UNITED STATES PATENT AND TRADEMARK OFFICE

APPLICATION NO.	FILING DATE	FIRST NAMED INVENTOR	ATTORNEY DOCKET NO.	CONFIRMATION NO.
10/523,186	01/28/2005	Iouri Kalinitchenko	02-38 US	8299

Office Action Summary

1. This Office Action is submitted in response to the preliminary amendment filed 1-28-2005, wherein claims 1-20 are pending.

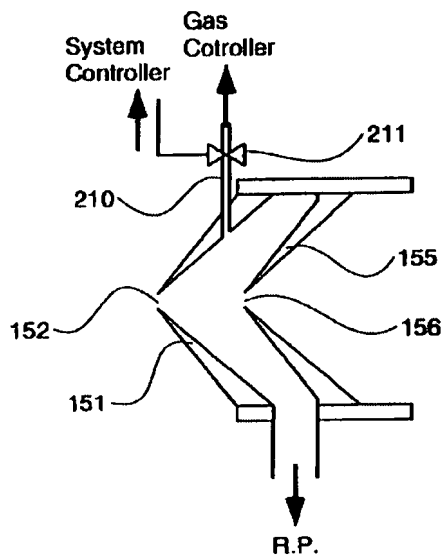
4. Regarding claim 1 , Sakata teaches interface section 150, which separates an atmospheric plasma source from the high vacuum analyser stage containing the mass spectrometer. (Note Figure 1 below)

The interface extracts ions from the plasma source through sampling cone 151 through the sampling orifice 152, then transferred into the analyzer stage by skimmer cone 155 through skimmer orifice 156. The interface stage is

normally maintained at 200-300 Pa, a relatively higher pressure than the pressure elsewhere in the vacuum chamber. Col. 4, lines 25-31; and 47-63.

6. Regarding claims 5 and 6, Sakata teaches the use of extraction electrode 161 located behind the skimmer cone (Note Figure 1 above), to focus the ion beam entering the chamber through the skimmer cone orifice into the mass filter situated in the analyzer stage. Col. 4, line 25-31; and Col. 4, line 47-63.

Fig.3

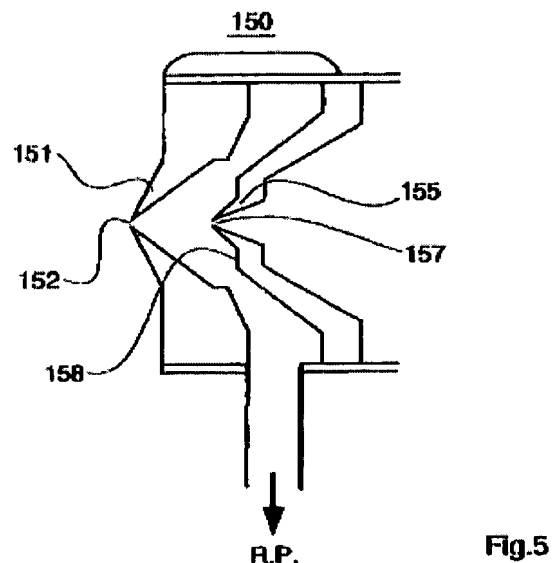
Sakata further teaches that an inlet 210 is fitted to the interface stage to enable the introduction of a gas (Note Figure 3 below). Introduction of gas (a substance) into the interface stage results in an increase of pressure, which increases ion collisions, and again dissociating the polyatomic ion species that give rise to spectral interferences. Col. 5, line 46-64.

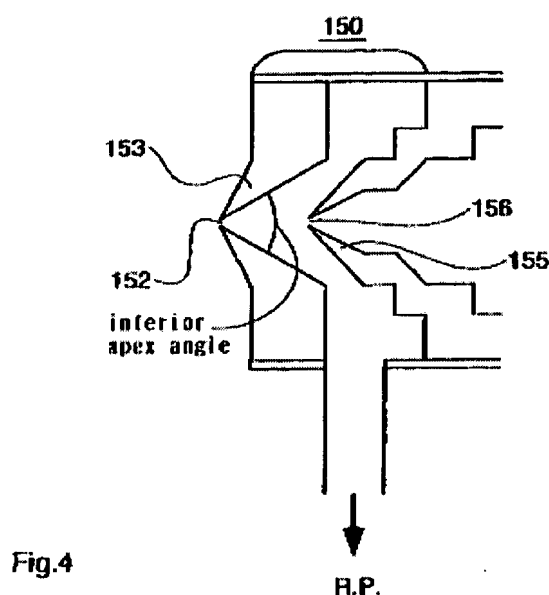
7. Regarding claims 9-11, Sakata teaches modifying the sampling cone, by narrowing the interior apex (Note Figures 4 and 5 below) to reduce the pumping efficiency behind the sampling orifice, leading to increased pressure in the region between the cone orifices. It should be noted in Figure 4 that the interface stage has parallel walls, and narrowing the apex angle makes the sampling cone longer.
